ONE 90 (PREVIOUSLY WATERS TECHNOLOGY PARK )  
PA 18-013 MODIFICATION SUBMITTAL :  
ISSUE DATE: 10-13-20

PA MODIFICATION - INTENT AND DESCRIPTION:  
To review and approve architectural building related design modifications made during plan check for code compliance and constructibility.

PA MODIFICATION COBALT- BLOCKS REVISIONS SUMMARY

PA MODIFICATION - INDIGO ROWS REVISIONS SUMMARY

GROUND LEVEL PLAN

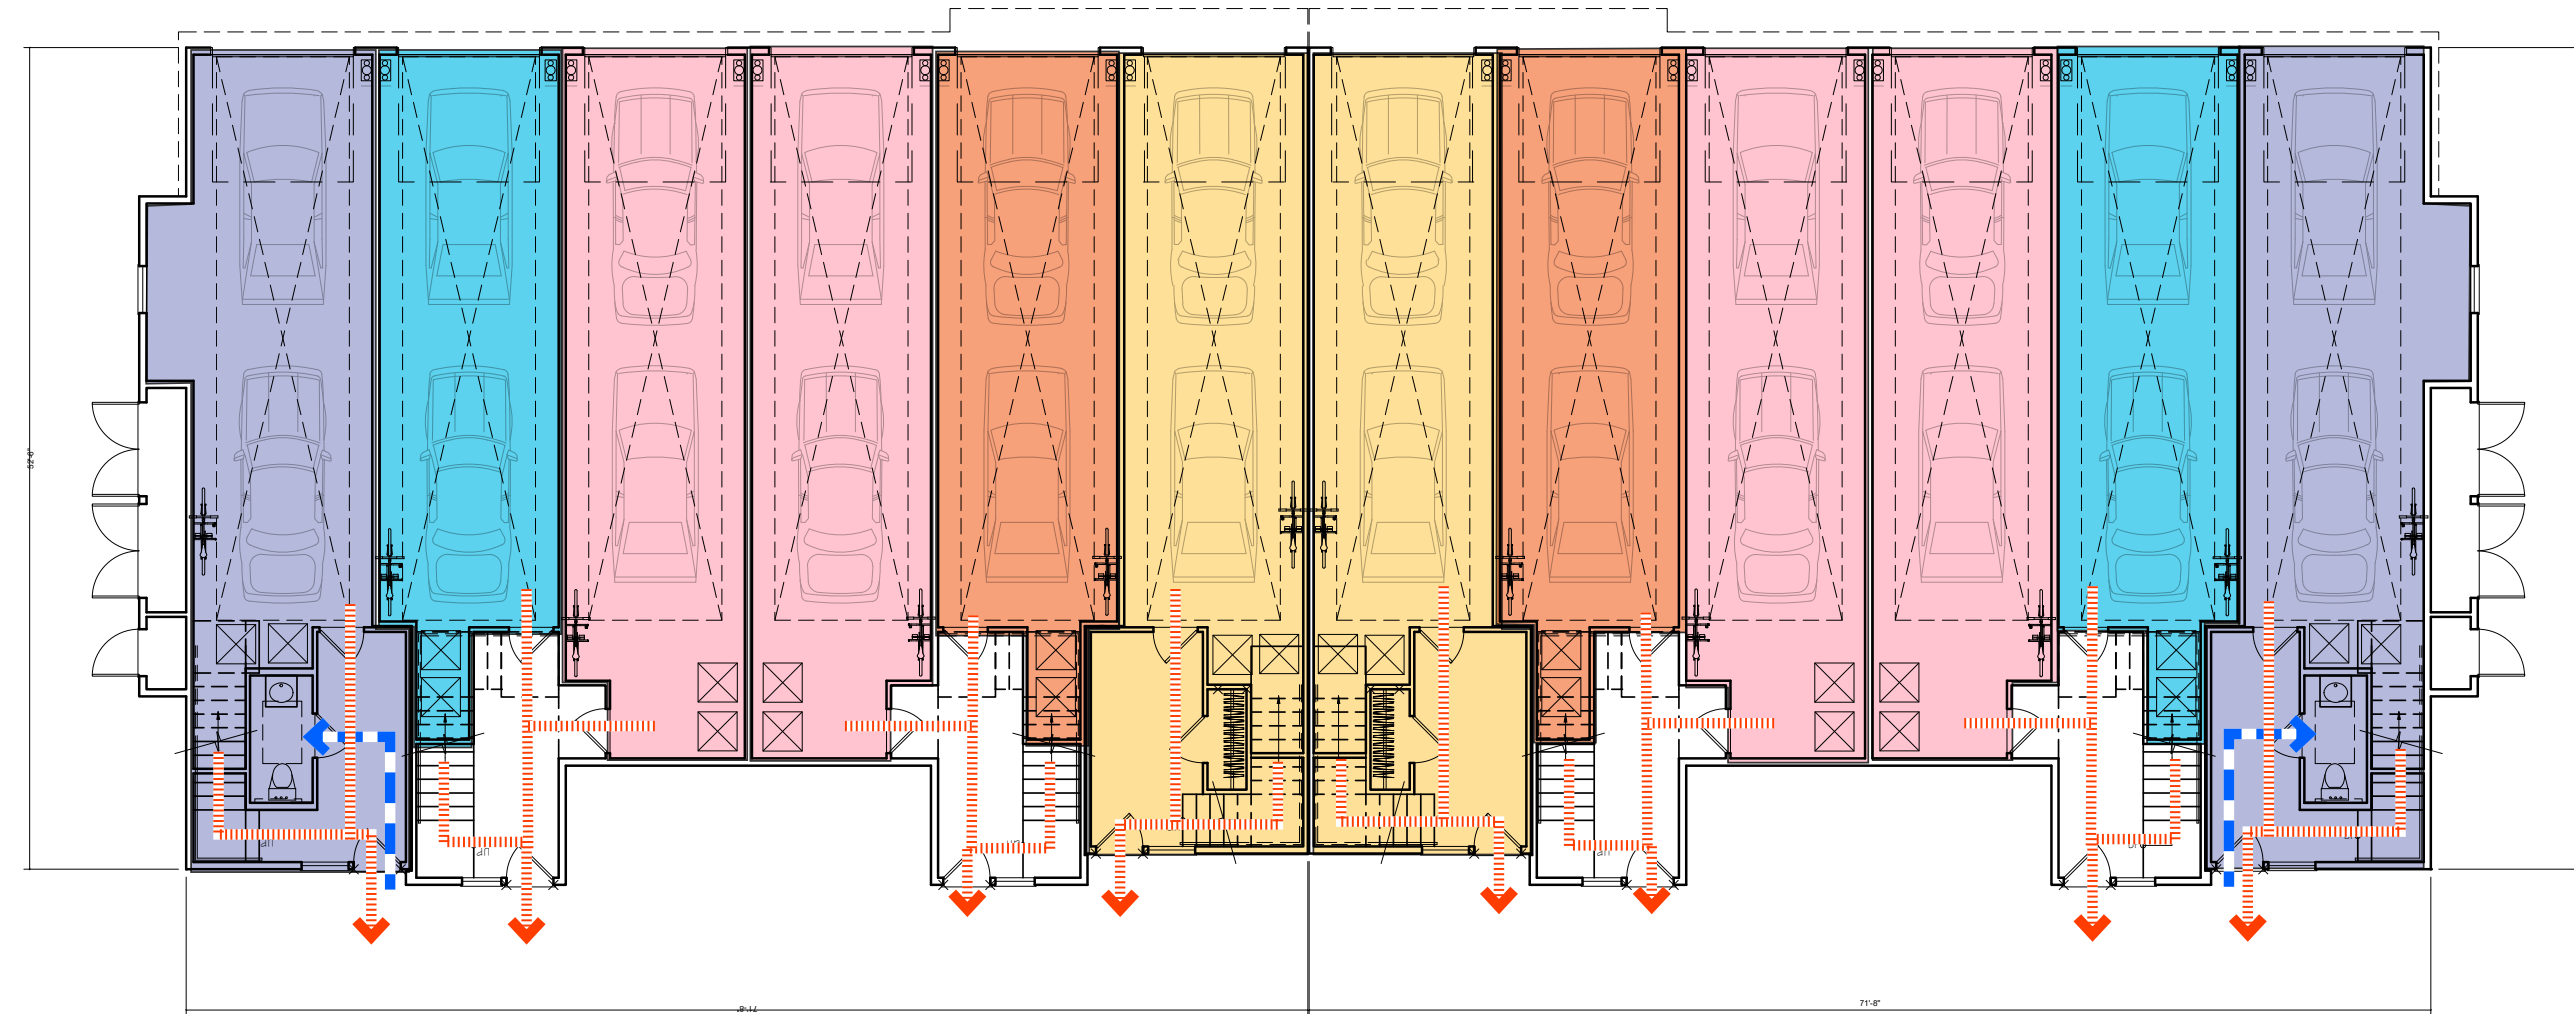
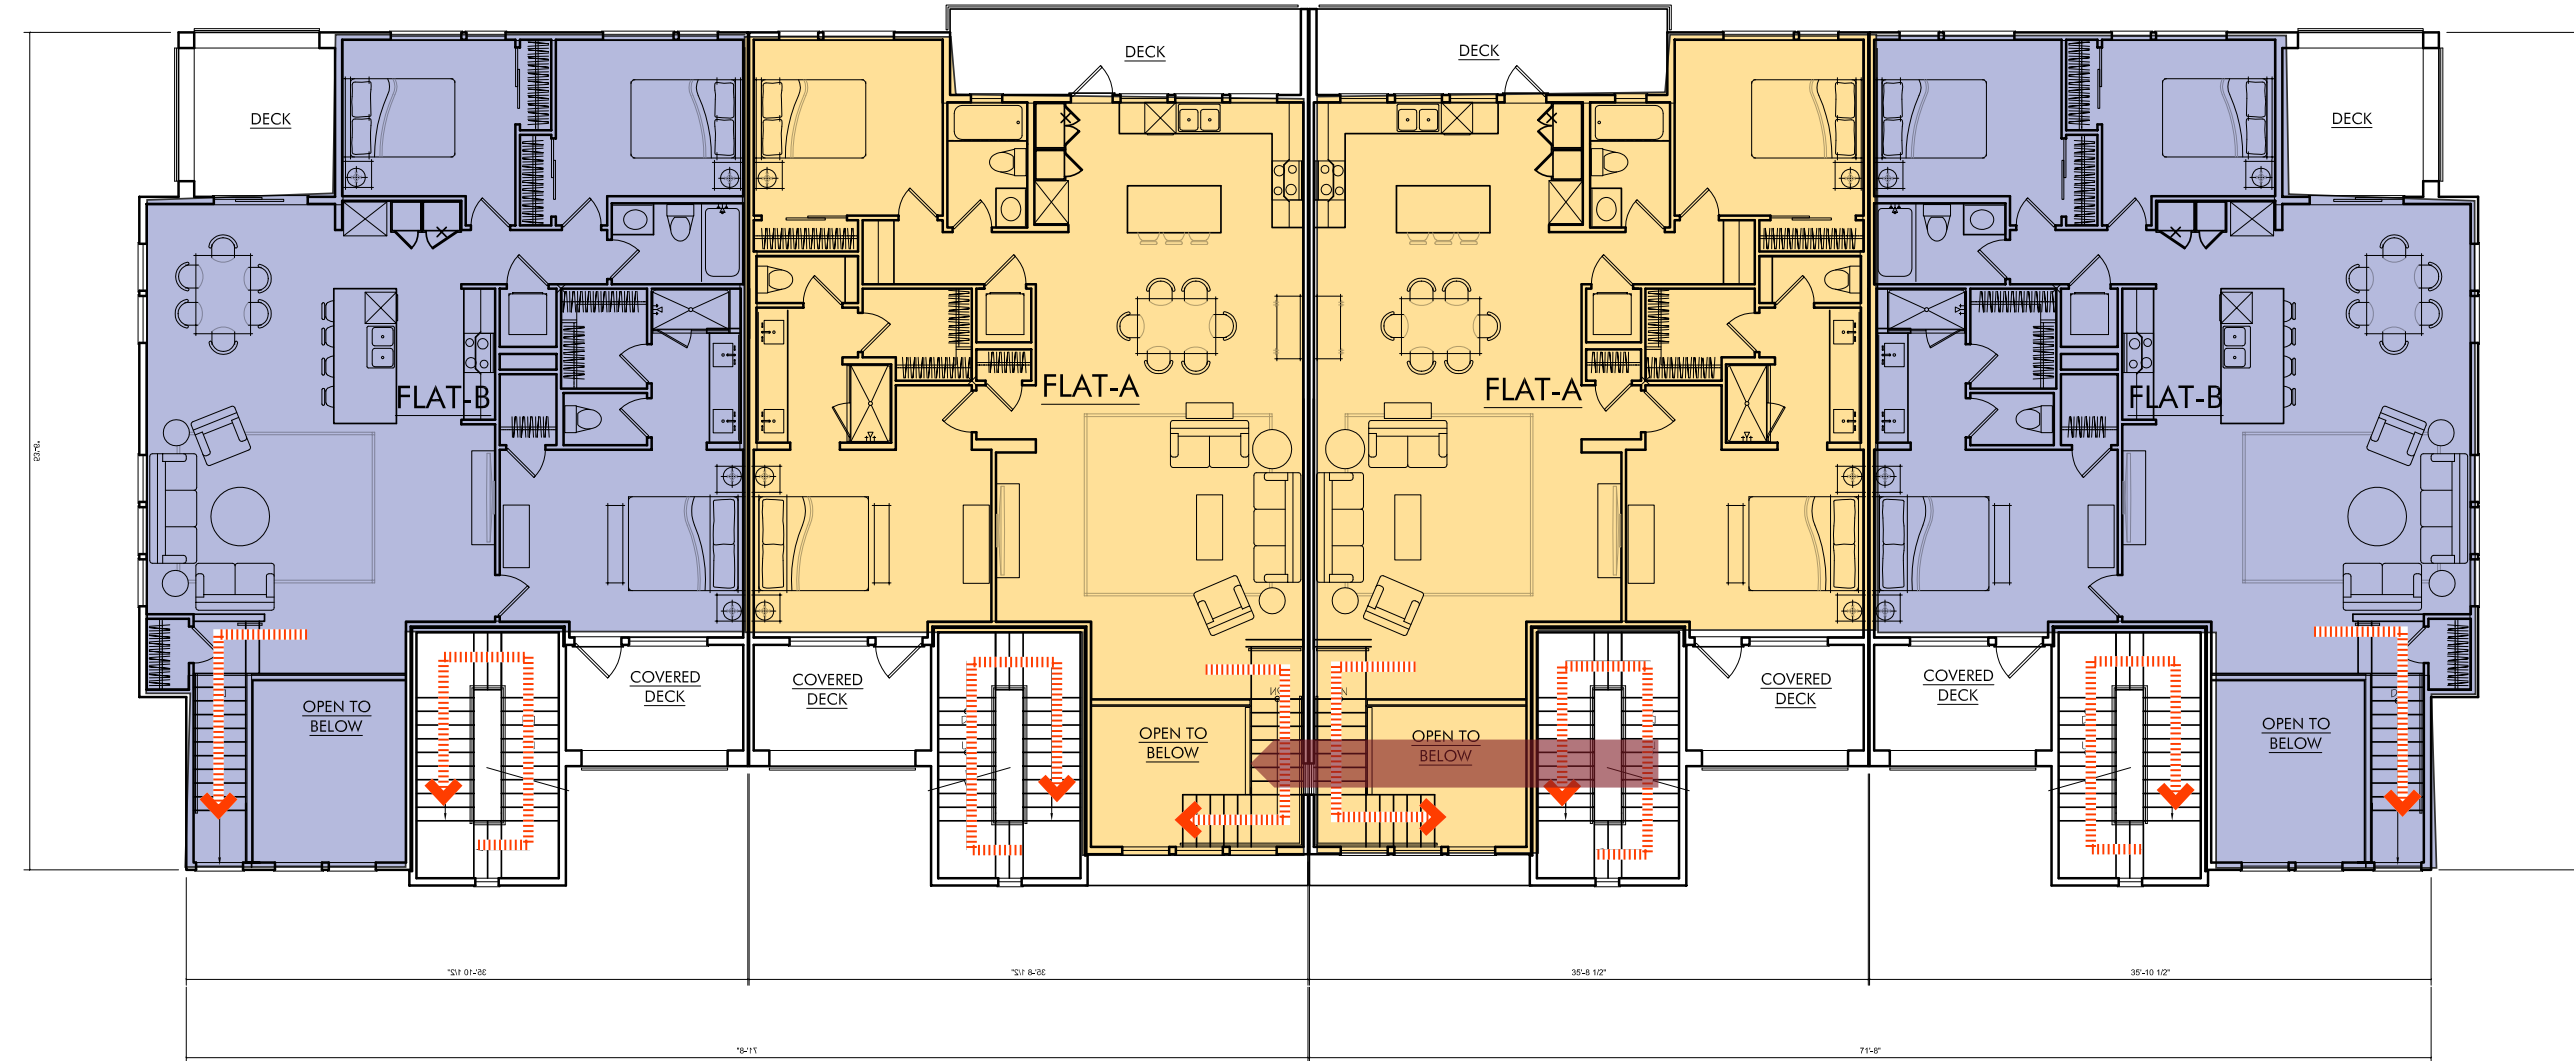
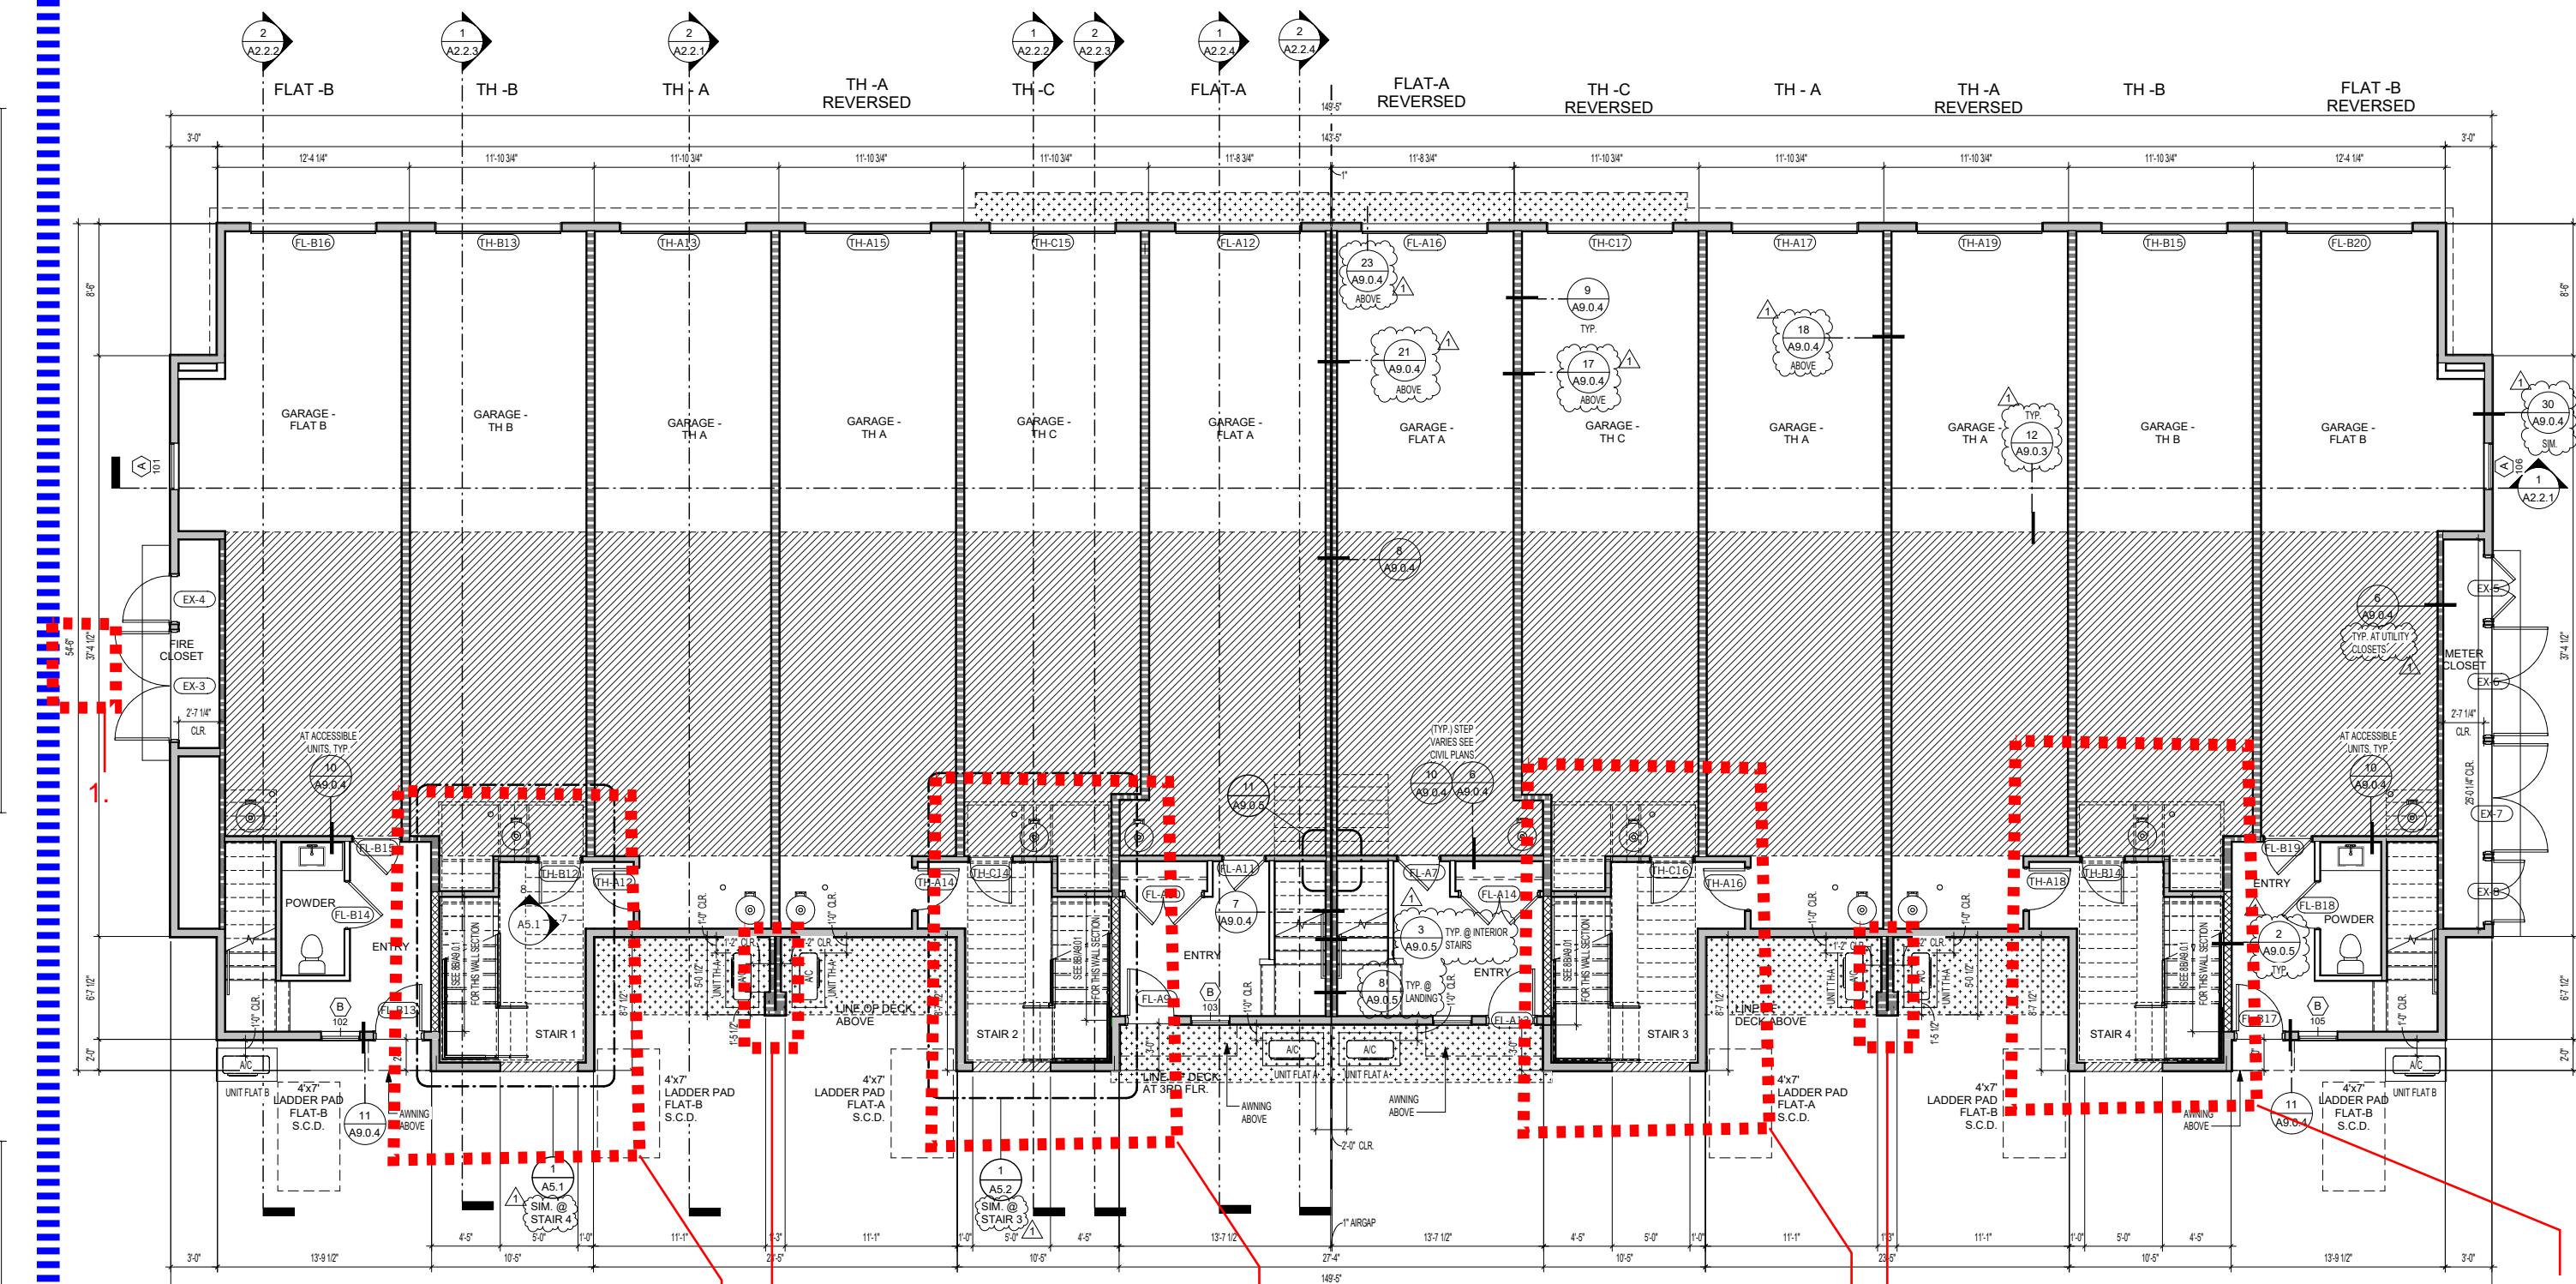
1. All common stairs within each building have been revised from enclosed stairs to covered open stairs to meet exiting requirement for TH units located on third floor. This revision allows stairs to be connected via egress balcony at third floor. The open stair required stair footprint to increase in depth by 1'-0".
2. Added framed structural wall to support balcony/decks on upper levels
3. Revised all patio/balcony unit doors from swing door to sliding door to maximize space in balcony and within the unit. Deck/balcony was extended to align with the egress balcony above. This does not impact the planning area calcs.
4. Revised metal trellis to structural weather treated wood and composite framing members.
